SECTION 00 91 15

ADDENDUM NUMBER 6

- 1.01 DATE: APRIL 6, 2021**
- 1.02 PROJECT: WELCOME CENTER**
- 1.03 PROJECT NUMBER: DCM NO. 2020604**
- 1.04 OWNER: ALABAMA A&M UNIVERSITY**
- 1.05 ARCHITECT: NOLA | VAN PEURSEM ARCHITECTS, PC**

2 WALL SECTION
 3/4" = 1'-0"

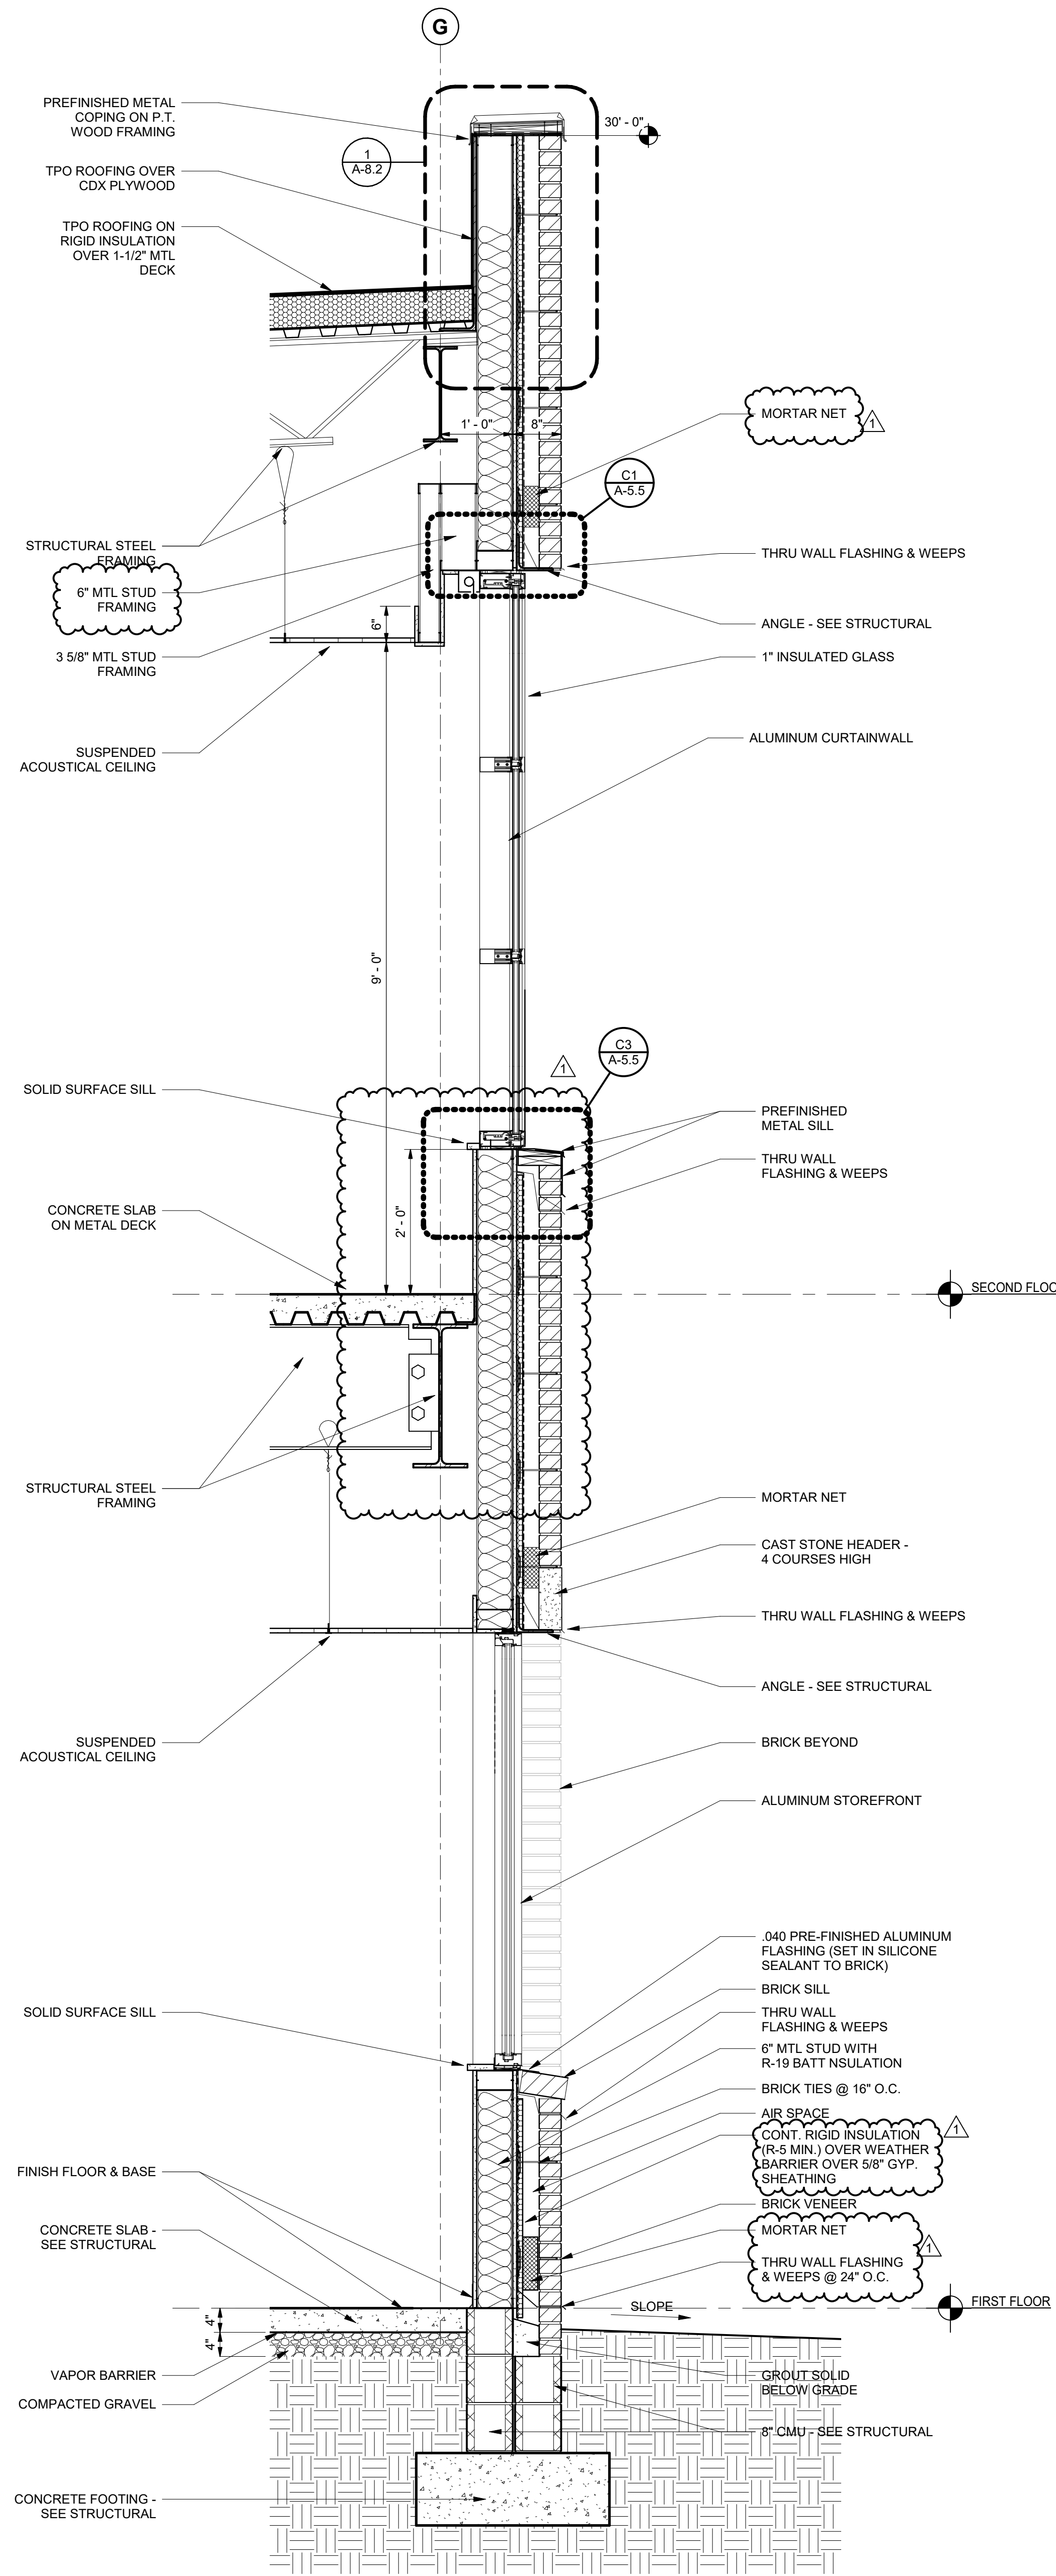
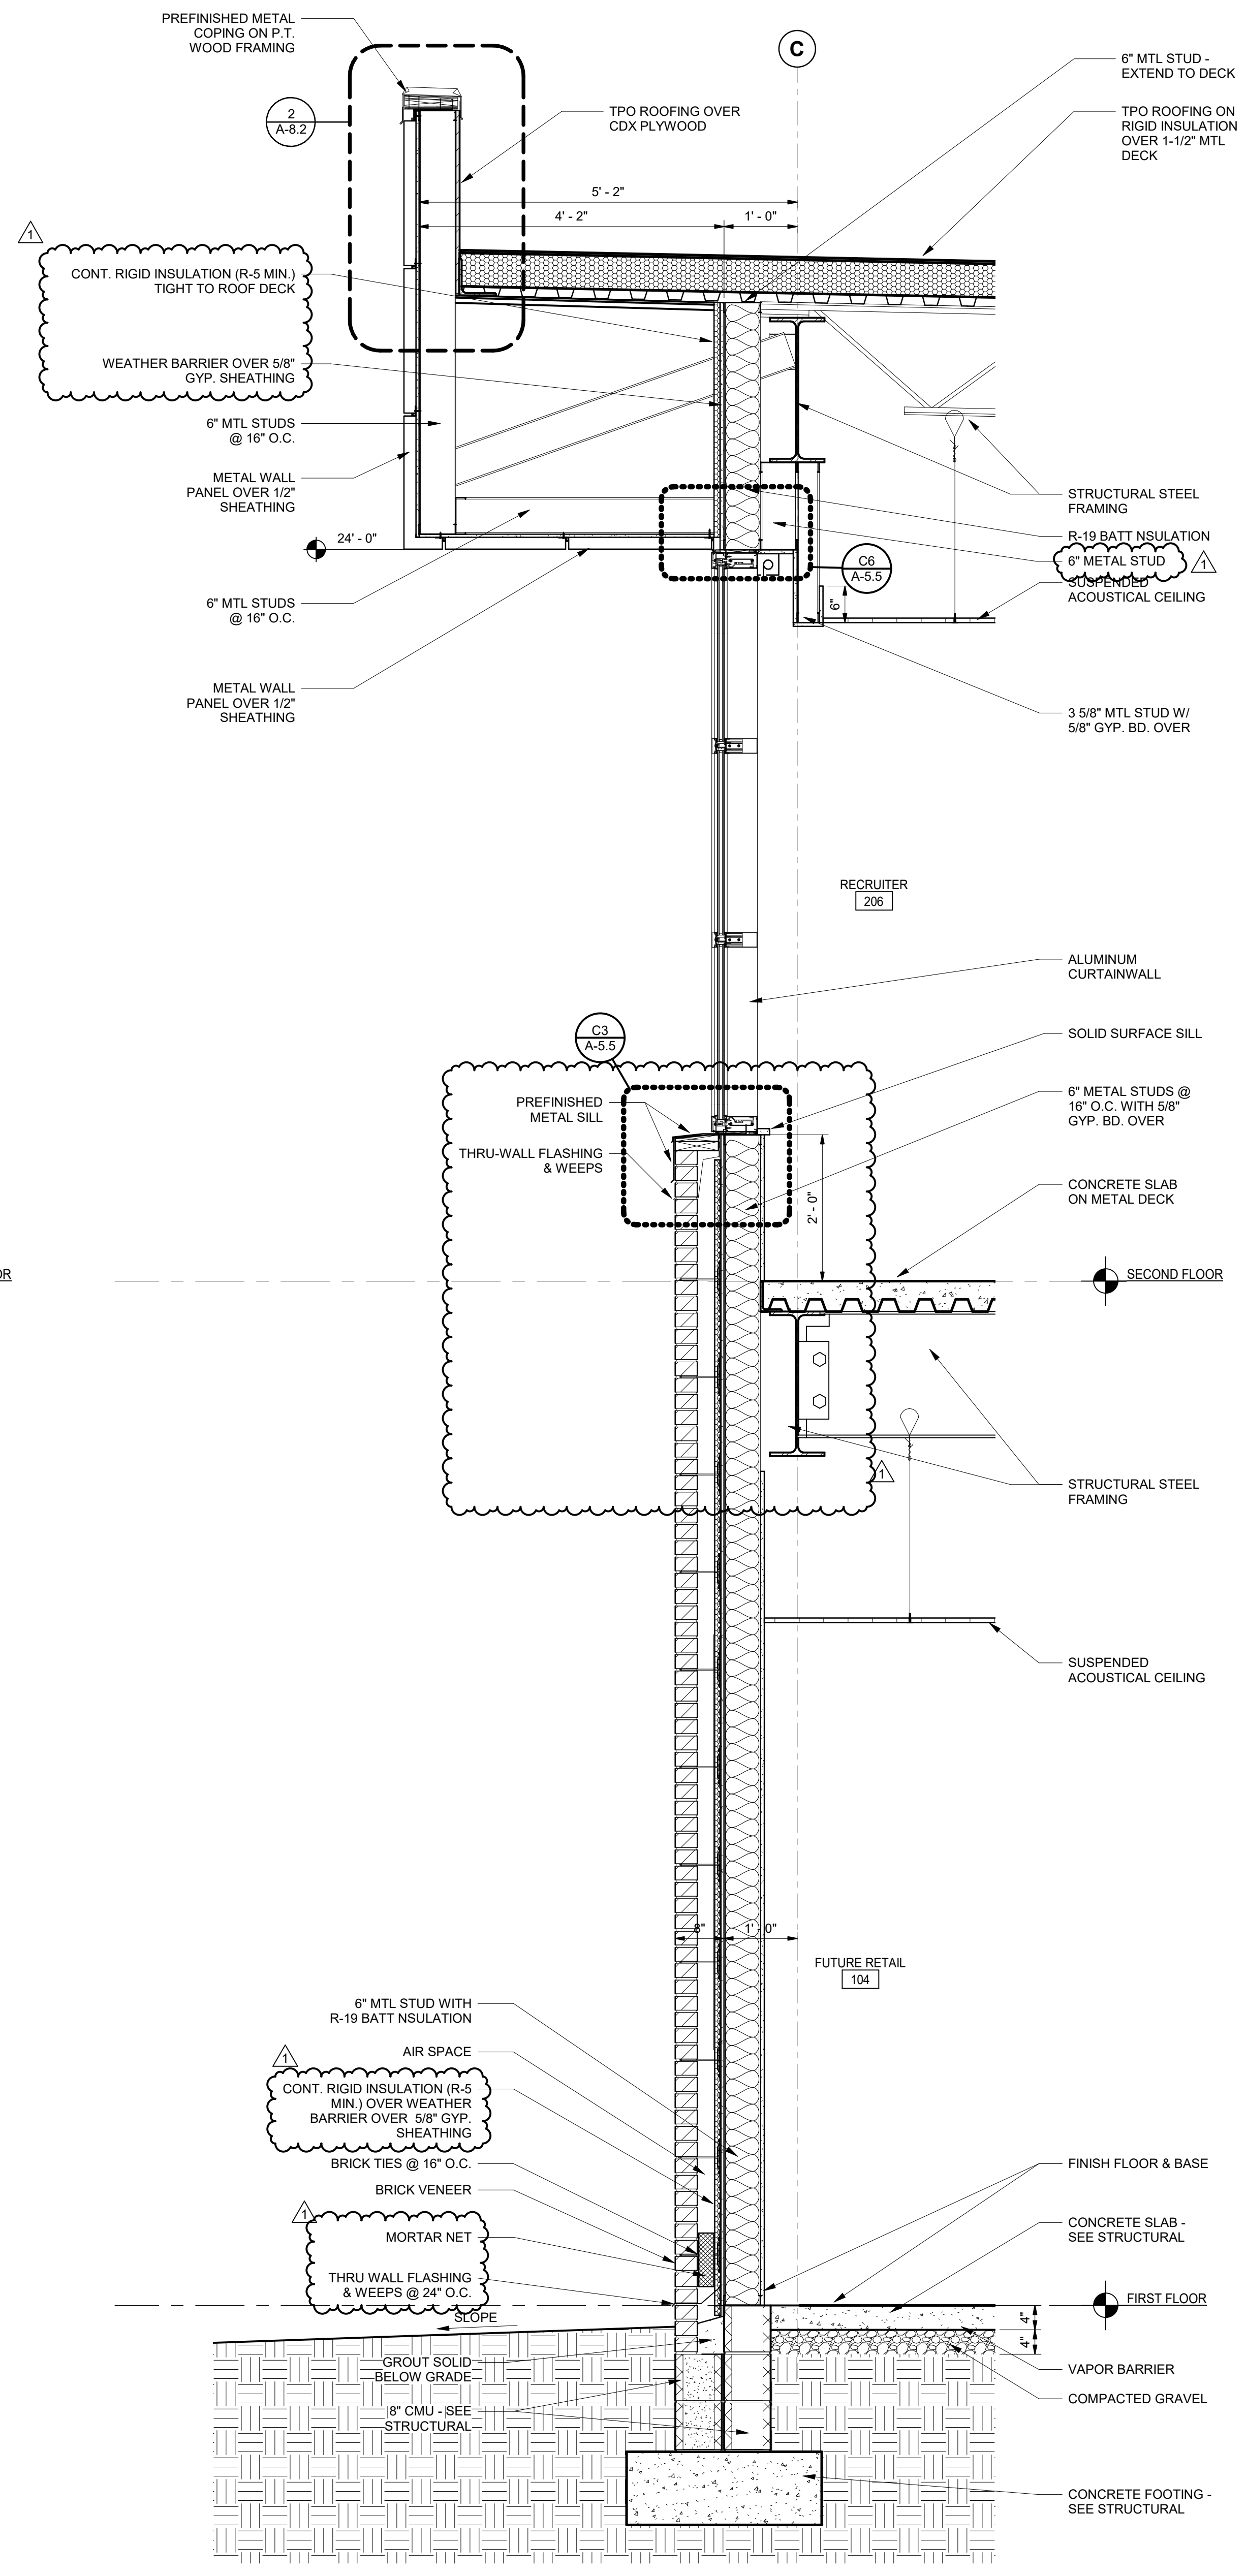
4.13 SHEET A-7.1 – WALL SECTIONS:

- A. Replace this sheet in its entirety. Revisions include the following:
1. Updated notes regarding weather barrier, mortar nets, and flashing.
 2. Updated exterior wall construction at second floor slab.
